IBR's bridge design (LPA) has a traffic "Auxiliary Lane".

# More lanes?

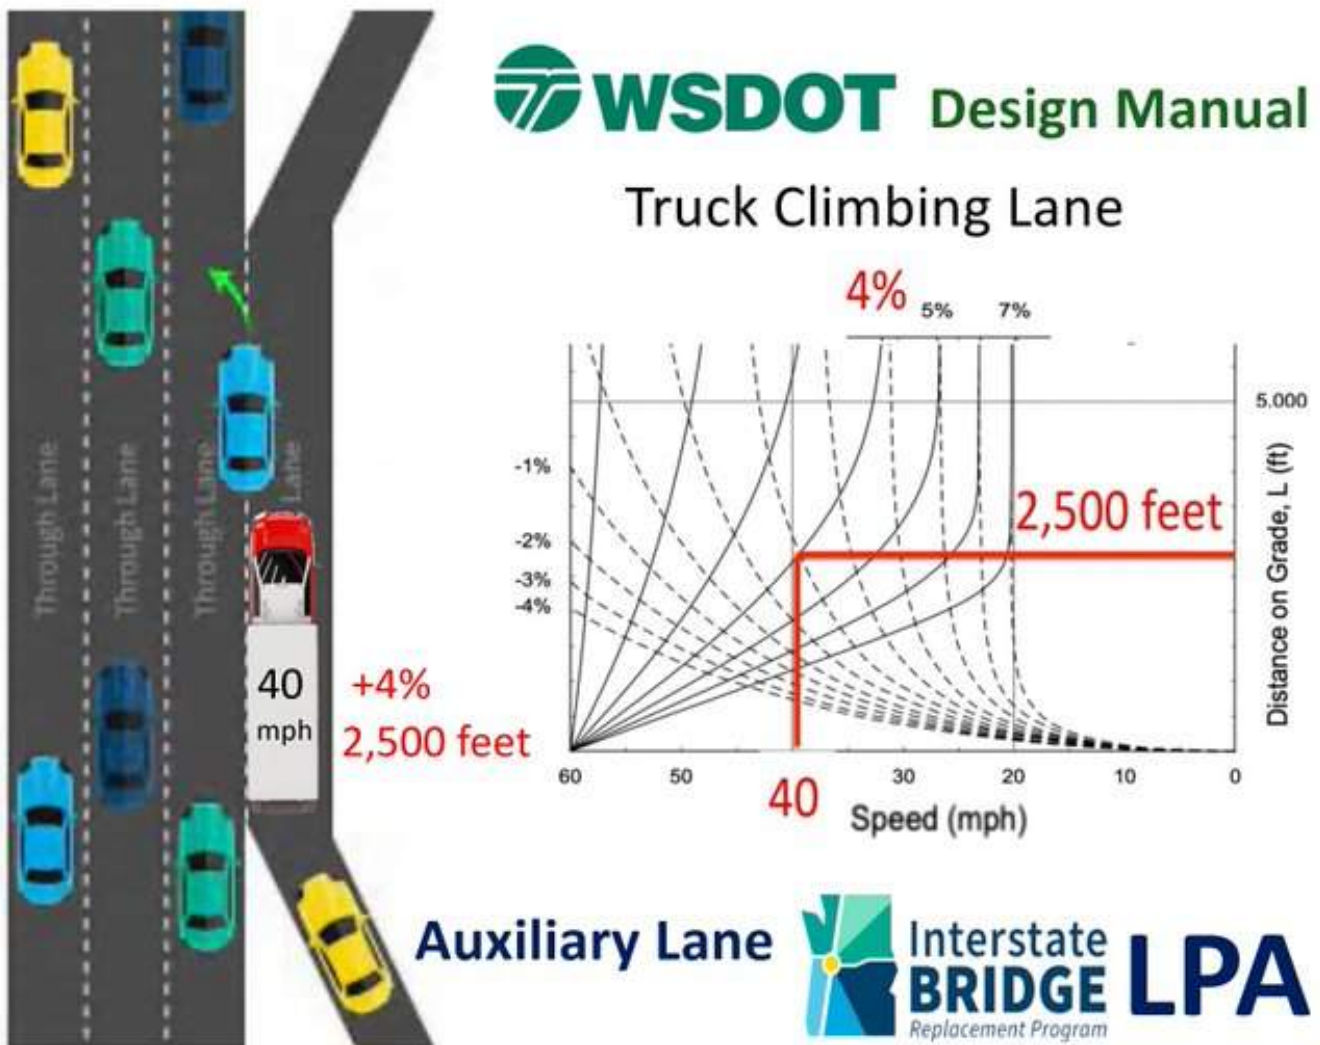
WSDOT Design Manual says because trucks will slow to 40 mph the bridge will need a "Truck Climbing Lane", but not addressed by the IBR.

Does the IBR want both? (10 lanes)
